MISSISSIPPI POWER & LIGHT COMPANY

SUBJECT: Grand Gulf Nuclear Station  
Units 1 and 2  
Docket Nos. 50-416 and 50-417  
File 0260/0862/L-340.0/L-334.0  
Transmittal of Proposed FSAR  
Changes and Responses to  
NRC Formal and Informal  
Questions  
AECM-81/345

- Attachments:
1. Question and Response 260.1
  2. Revised Question and Response 362.7
  3. HGEB SER Open Item - Ultimate Heat Sink
  4. NRC Concern - Shared Systems
  5. SER Open Item - Soil-Structure Interaction

SETTLEMENT VS TIME  
UNITS 1 & 2  
CONTAINMENT BUILDING  
FIGURE 2.5-75f SHEET 1 OF 2

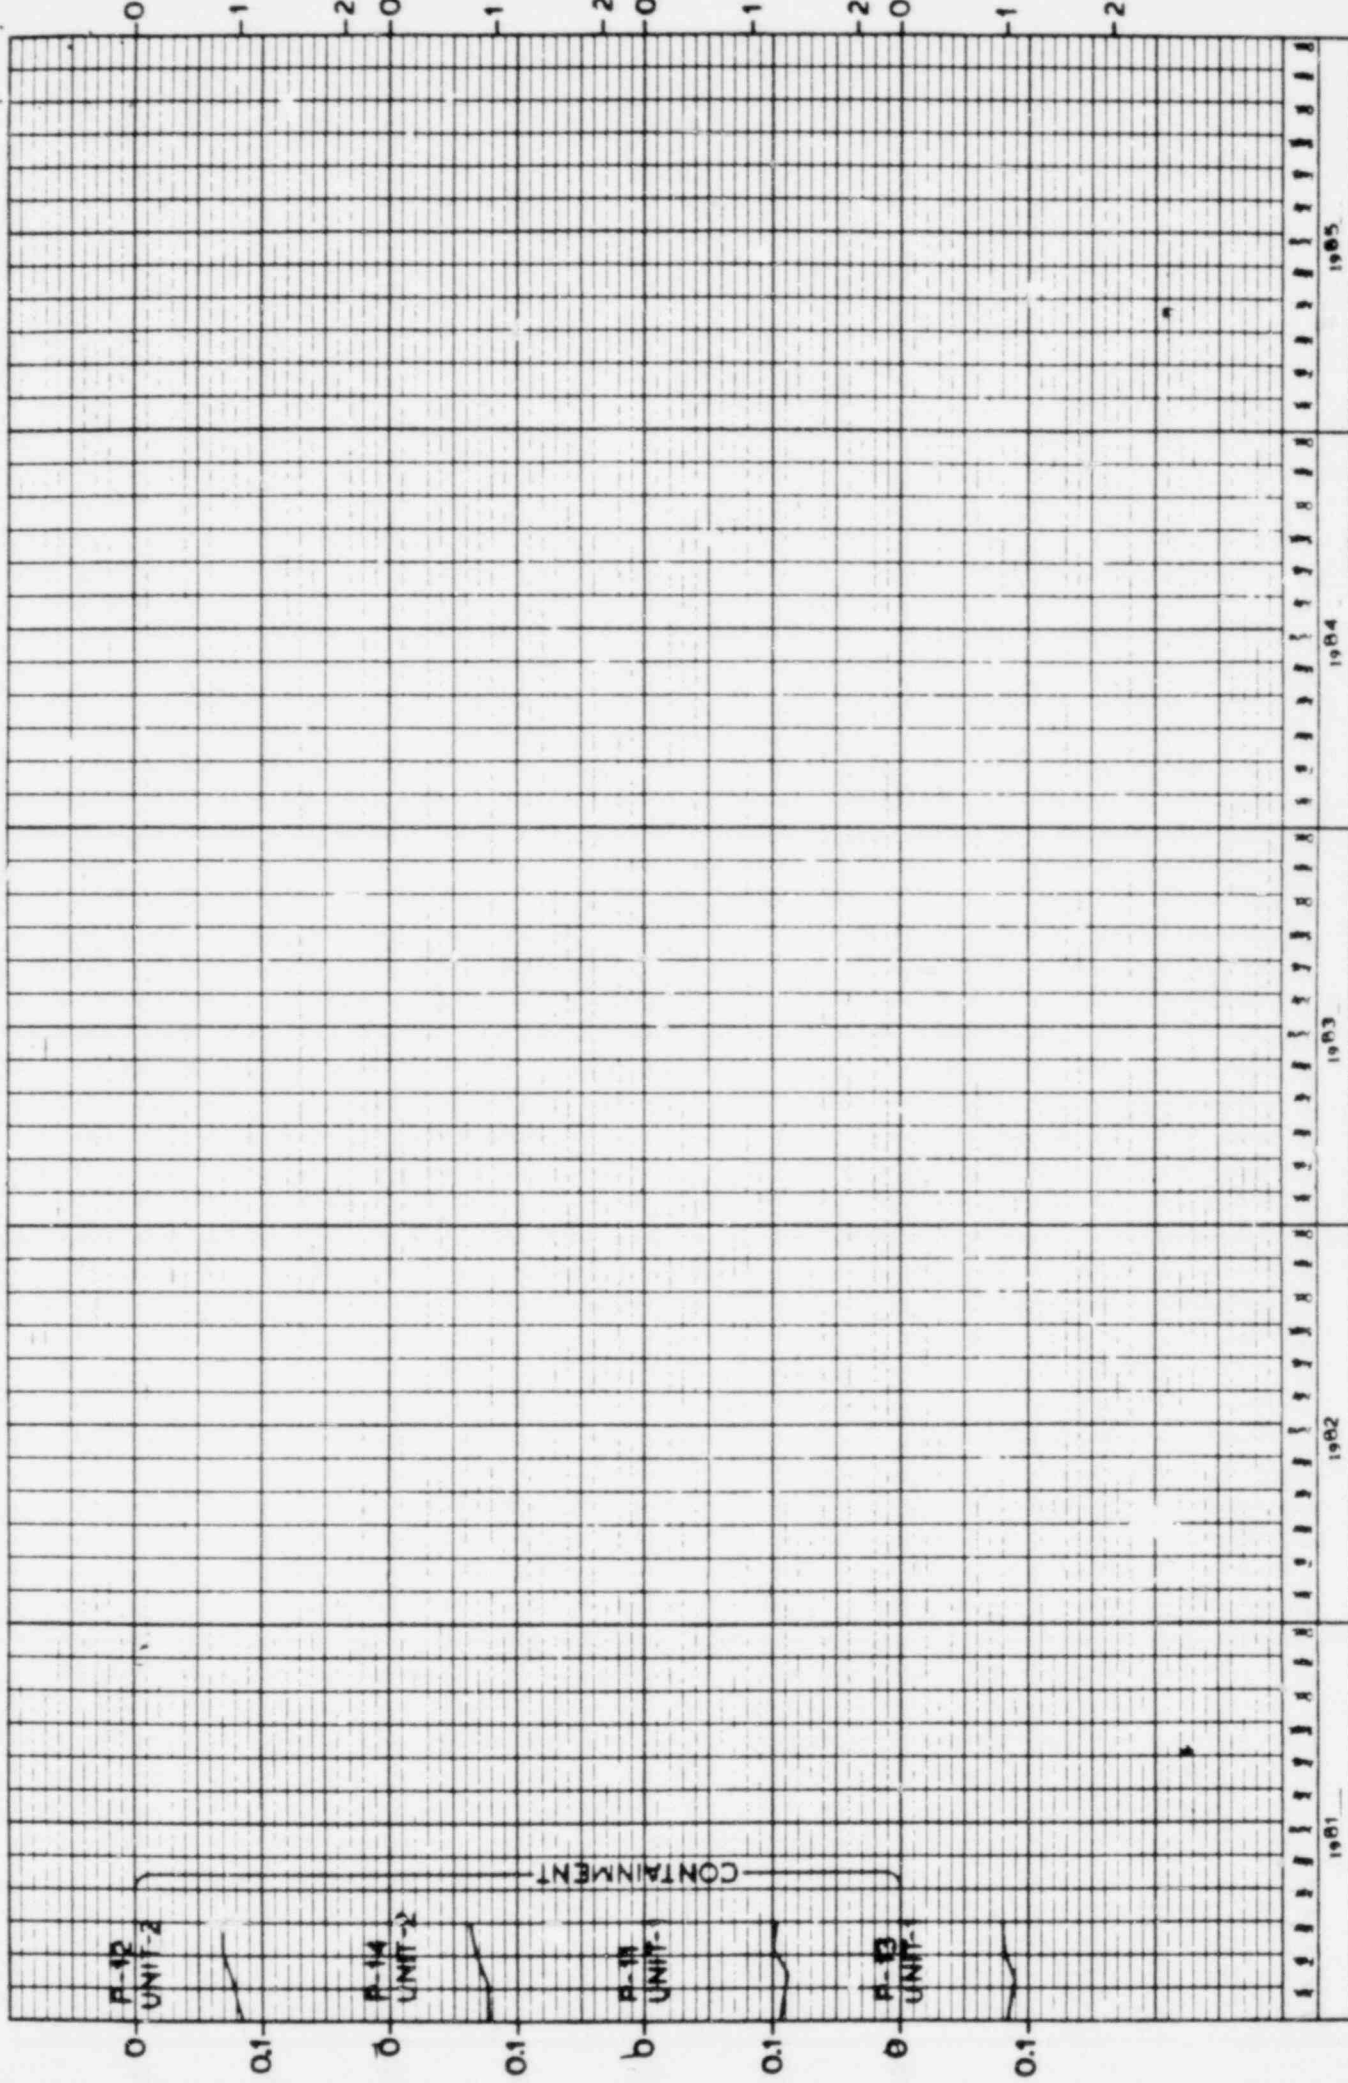
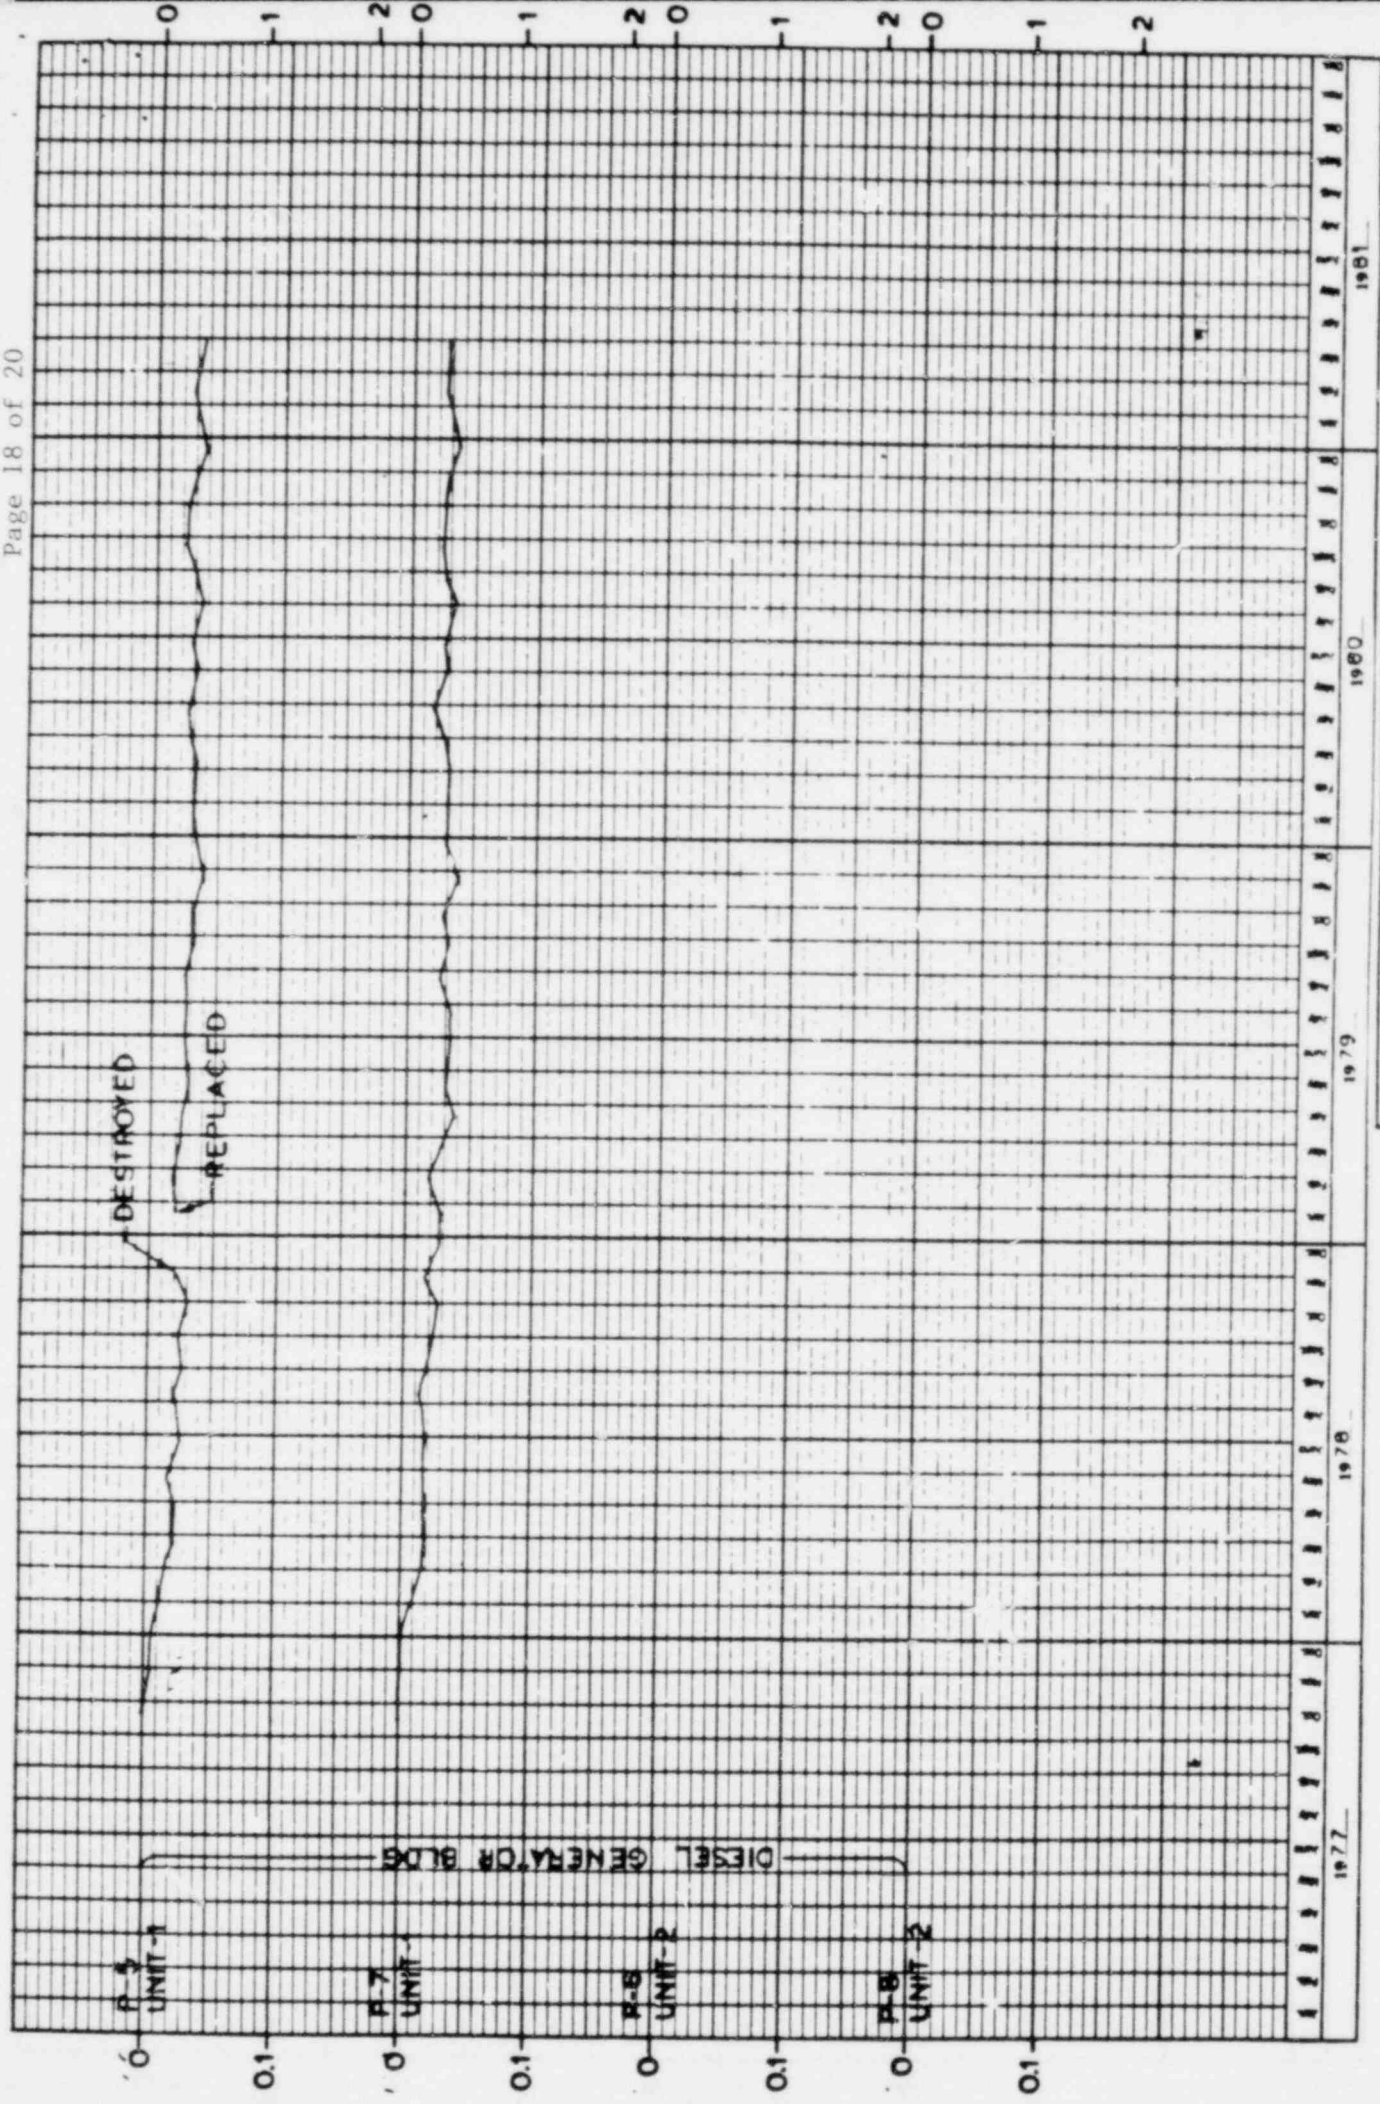
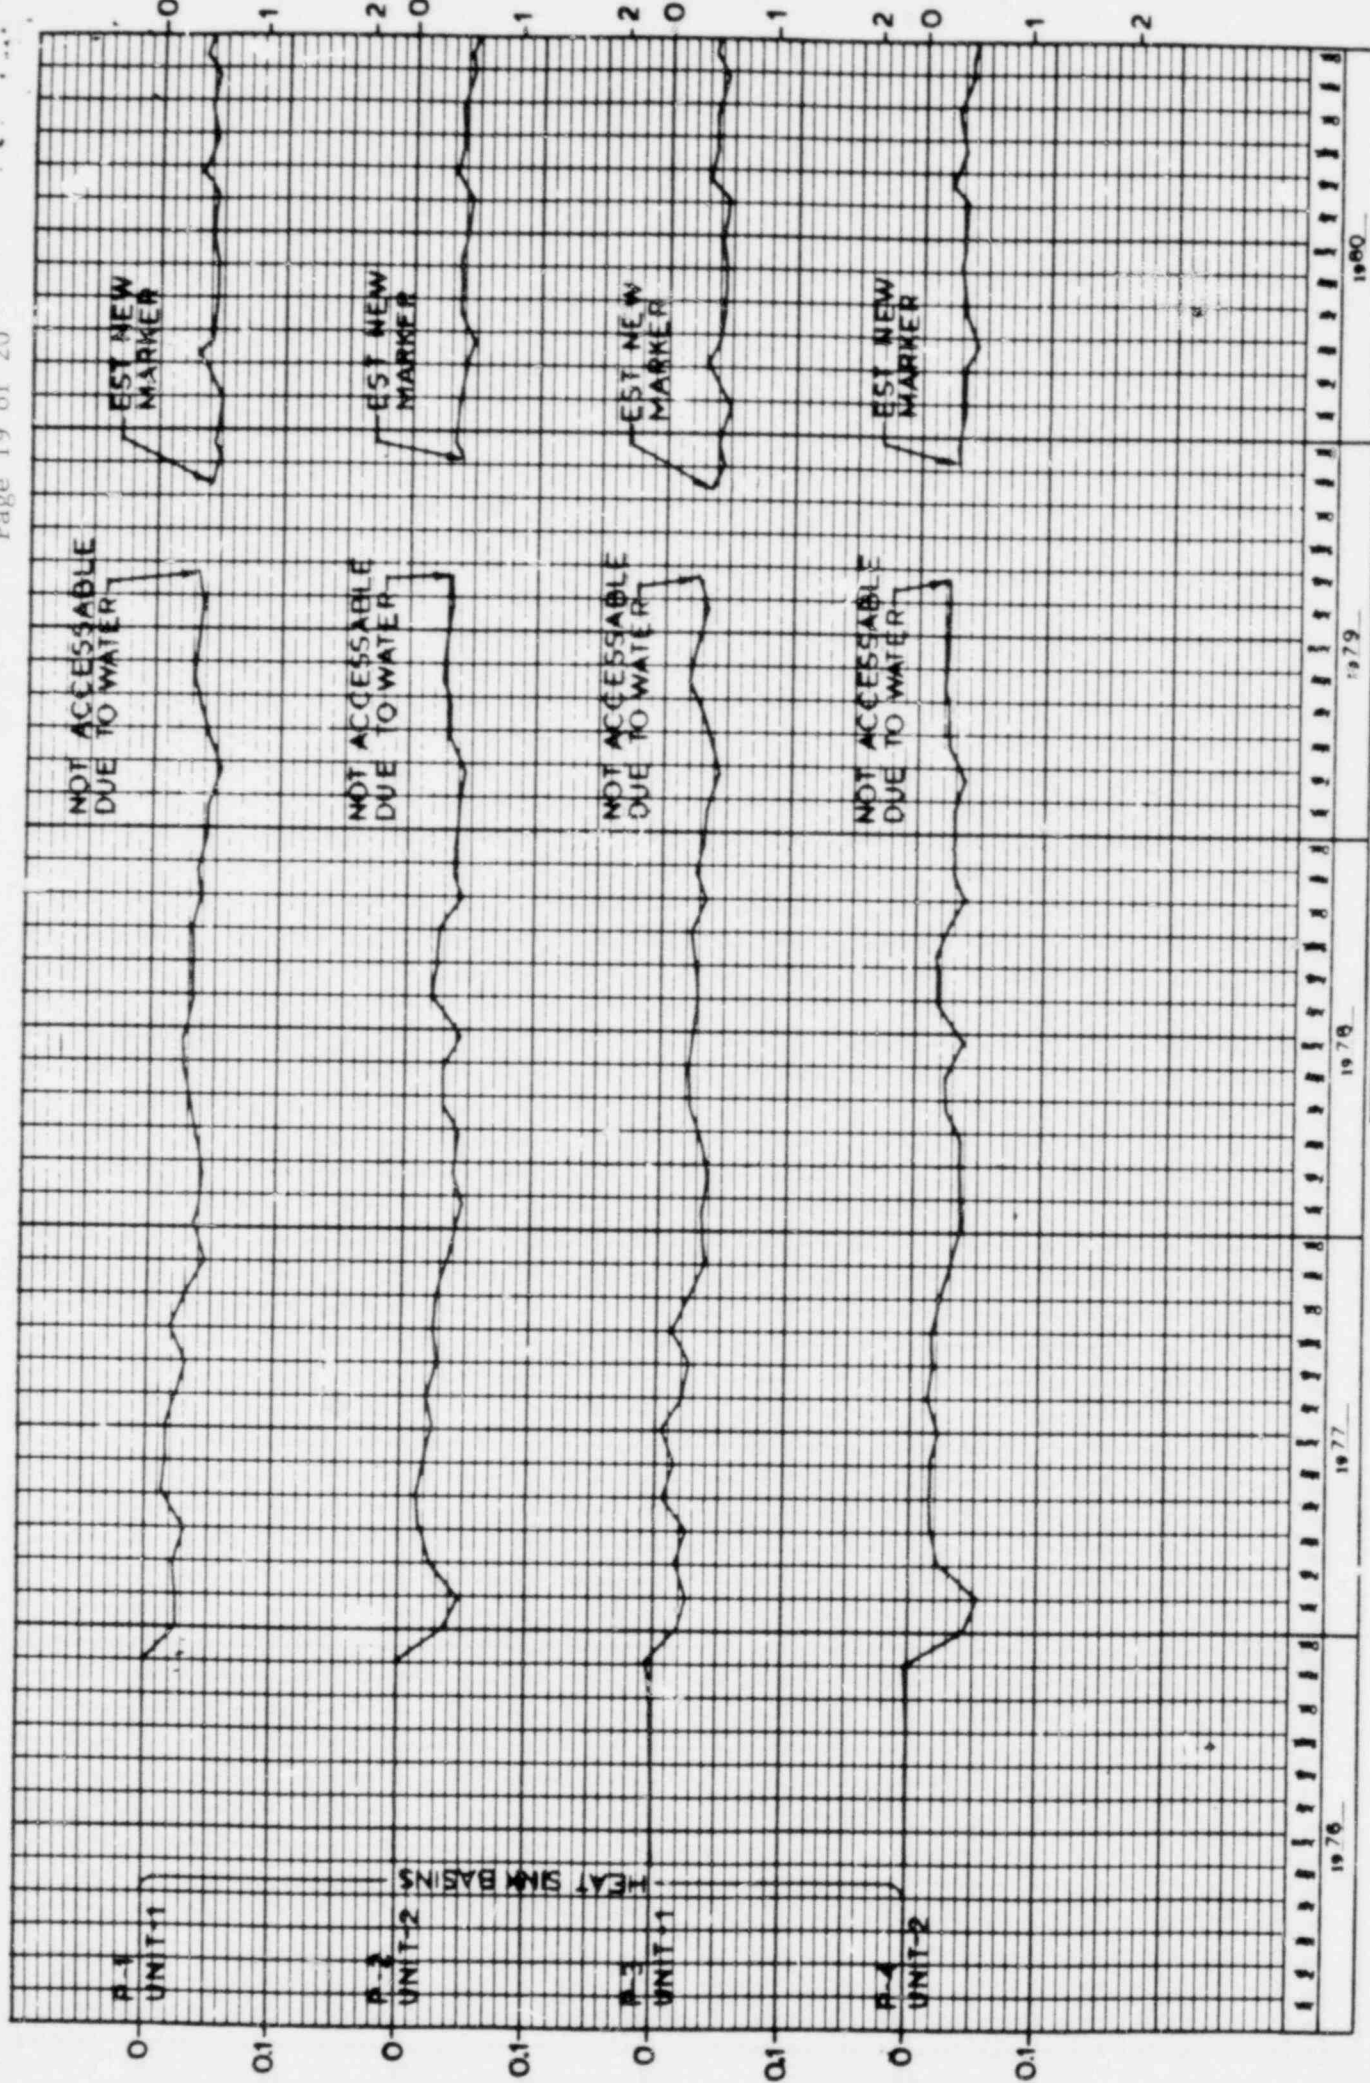
362.7 Your response to NRC Question 362.5 (page Q&R 2.5-14, Amendment 30) is not complete. Indicate what measured value of differential settlement would cause code allowable stresses to be exceeded for individual buildings and buried piping and require notification of NRC. Provide a table of these values and the limiting stress criteria. Update the plots which show settlement recorded to date versus time; this is particularly important since construction of Unit 2 was still underway when your response to Question 362.5 was being developed.

The response to this question is given in revised subsection 2.5.4.13.1, revised Table 2.5-10, and revised Figures 2.5-75a through 2.5-75h.

The settlement markers will be read at one-month intervals until construction is complete and all pools are filled with water, at which time the results of the settlement monitoring program will be evaluated and long-term monitoring of the structures will be assessed. Total settlement will not be a Geotechnical concern until the following measured values are observed:

Turbine building	3"
Radwaste building	3"
Control building	3"
Containment building	3.5"
Auxiliary building	3.5"
Diesel generator building	3"
